UNITED STATES PATENT AND TRADEMARK OFFICE

APPLICATION NO.	FILING DATE	FIRST NAMED INVENTOR	ATTORNEY DOCKET NO.	CONFIRMATION NO.
10/726,223	12/01/2003	Joseph H. Martin	3741	
75	90 10/28/2005 .		EXAM	INER
Donald W. Meeker			CADUGAN, ERICA E	
Patent Agent 924 East Ocean	Front #E		ART UNIT	PAPER NUMBER
Newport Beach, CA 92661			3722	
			DATE MAILED: 10/28/2005

DETAILED ACTION

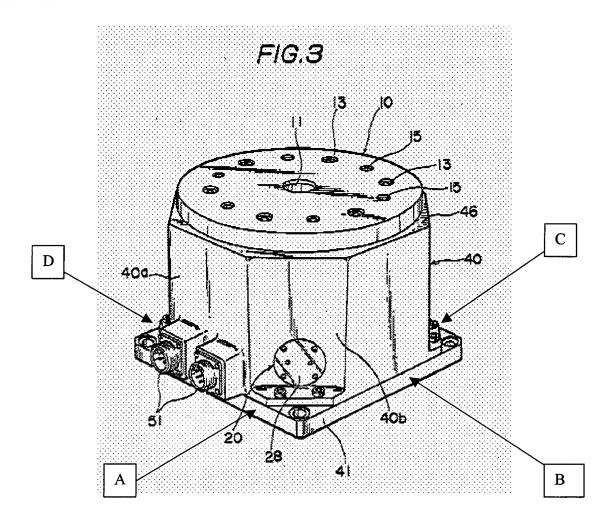
Specifically, as shown in the above labeled reproduction of Figure 3 from Teramachi, note that the indexer can be gripped by a vice to be held in a position where the table 10 extends in a generally horizontal plane (which position could be considered to be the "vertical position" of the block in the claim in that the block is thus positioned to rotate the table about a vertical axis, or which could be alternatively considered to be the "horizontal position" of the block in the claim in that the block holds the table in a position where it extends in a generally horizontal plane) by opposing vise jaws that contact sides B and D, or by opposing vise jaws that contact sides A and C. Additionally, particularly in light of the teachings of Teramachi that the indexer

"can be used in any position" and that the indexer can be used in "the vertical state in which the rotary table 10 rotates in a vertical plane" (col. 4, lines 50-58), it is noted that if the indexer was repositioned such that the table 10 rotates in a generally vertical plane, then it is noted that the indexer can be so arranged such that opposing vise jaws grip opposing sides A and C or grip opposing sides B and D in order to hold the device with the table 10 rotating in the vertical plane.

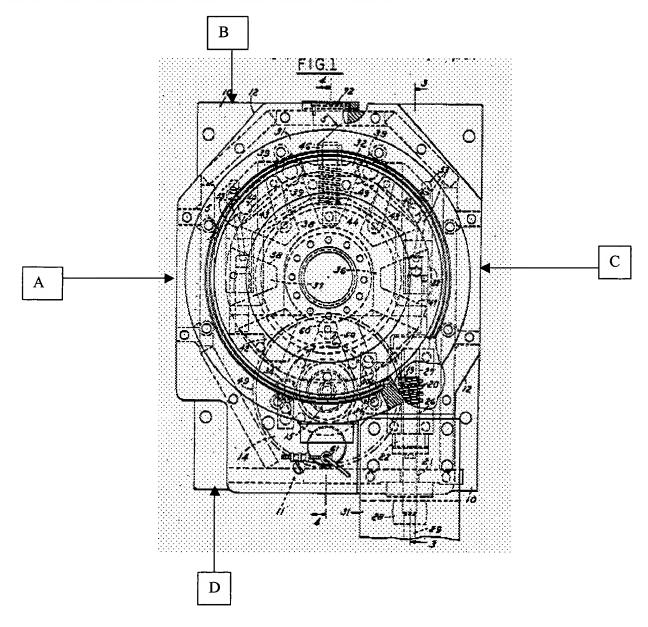
Specifically, as shown in the above labeled reproduction of Figure 1 from Bell, Sr., note that the indexer can be gripped by a vice to be held in a position where the table 32 extends in a generally horizontal plane (which position could be considered to be the "vertical position" of

the block in the claim in that the block is thus positioned to rotate the table about a vertical axis, or which could be alternatively considered to be the "horizontal position" of the block in the claim in that the block holds the table in a position where it extends in a generally horizontal plane) by opposing vise jaws that contact sides B and D, or by opposing vise jaws that contact sides A and C. Additionally, it is noted that if the indexer was repositioned such that the table 32 rotates in a generally vertical plane, then it is noted that the indexer can be arranged such that opposing vise jaws grip opposing sides A and C or grip opposing sides B and D in order to hold the device with the table 10 rotating in the vertical plane.

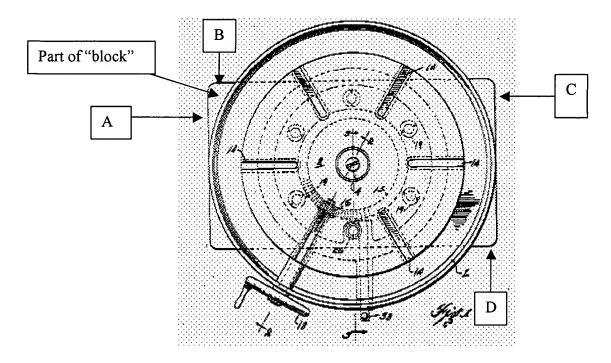
Specifically, as shown in the above labeled reproduction of Figure 1 from Buhr, note that the indexer can be gripped by a vice to be held in a position where the table 2 extends in a generally horizontal plane (which position could be considered to be the "vertical position" of the block in the claim in that the block is thus positioned to rotate the table about a vertical axis, or which could be alternatively considered to be the "horizontal position" of the block in the claim in that the block holds the table in a position where it extends in a generally horizontal plane) by opposing vise jaws that contact sides B and D, or by opposing vise jaws that contact sides A and C. Additionally, it is noted that if the indexer was repositioned such that the table 2 rotates in a generally vertical plane, then it is noted that the indexer can be arranged such that opposing vise jaws grip opposing sides A and C or grip opposing sides B and D in order to hold the device with the table 2 rotating in the vertical plane.

Re claim 2, as broadly claimed, the grooves 14 are used to "chuck" a workpiece to the table 2, and are located mounted in the table 2. Note that the table is, as broadly claimed, a "cylinder".

Re claim 4, inherently, there must be some sort of structure that engages the grooves 14 to enable the workpieces to be clamped to the table (i.e., the grooves all by themselves don't function to clamp anything). Whatever structure there inherently is that so engages these grooves is considered to be the claimed "brackets".

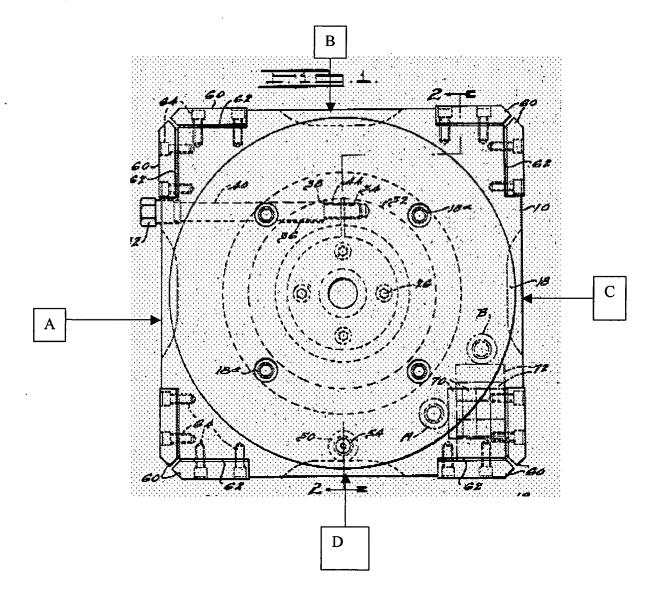
Specifically, as shown in the above labeled reproduction of Figure 1 from Saunders, note

that the indexer can be gripped by a vice to be held in a position where the table 18 extends in a

generally horizontal plane (which position could be considered to be the "vertical position" of

the block in the claim in that the block is thus positioned to rotate the table about a vertical axis,

or which could be alternatively considered to be the "horizontal position" of the block in the

claim in that the block holds the table in a position where it extends in a generally horizontal

plane) by opposing vise jaws that contact sides B and D, or by opposing vise jaws that contact

sides A and C. Additionally, it is noted that if the indexer was repositioned such that the table 2

rotates in a generally vertical plane, then it is noted that the indexer can be arranged such that

opposing vise jaws grip opposing sides A and C or grip opposing sides B and D in order to hold

the device with the table 18 rotating in the vertical plane.

Re claim 9, note that grooves 44, one of which is shown in Figure 2, are located in each of the aforedescribed four sides A-D (Figure 1), and are used "for reception of suitable or conventional clamping means (not shown) employed for clamping the base 10 to the table of the supporting surface of a machine tool or the like" (col. 3, lines 18-22). Thus, at least as broadly claimed, these grooves 44 serve to "align" the block 10 as they are engaged by the clamping means.
